# Access Compliance Report

| Intersection ID: 27921                  | Main Street: BLAKENEY_HEATH_RD | Cross Street: CHARNWOOD_CT              | Location: E            |
| ADA ID: 75FD17CEBA56                    | Ramp Type: PerpDiag            | Initial Pass/Fail: Fail                 | Overall Compliance: No |

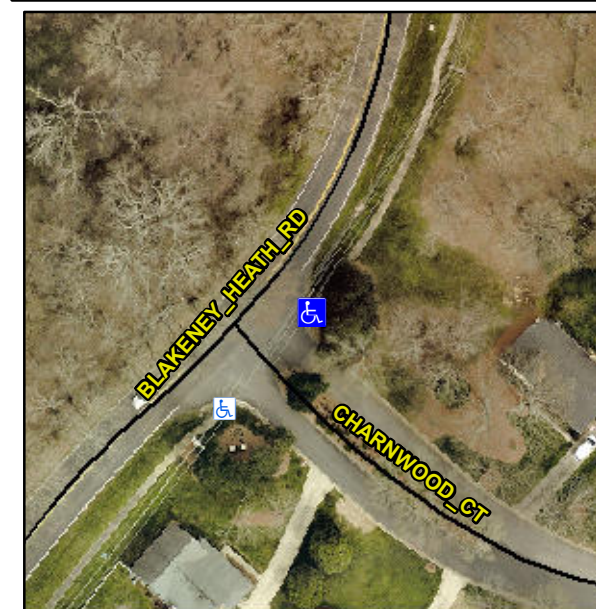
**R304.2.2, R304.5.3**

| Compliance | Description           | Data  | Compliance | Description                 | Data  |
|------------|-----------------------|-------|------------|-----------------------------|-------|
| N/A        | Ramp Length (in)      | 65.0  | No         | Ramp Slope (%)              | 12.2  |
| Yes        | Ramp Width (in)       | 48.0  | No         | Ramp XSlope (%)             | 5.9   |

**Remove & Replace Curb Ramp With Two New Directional Ramps or Equivalent.**
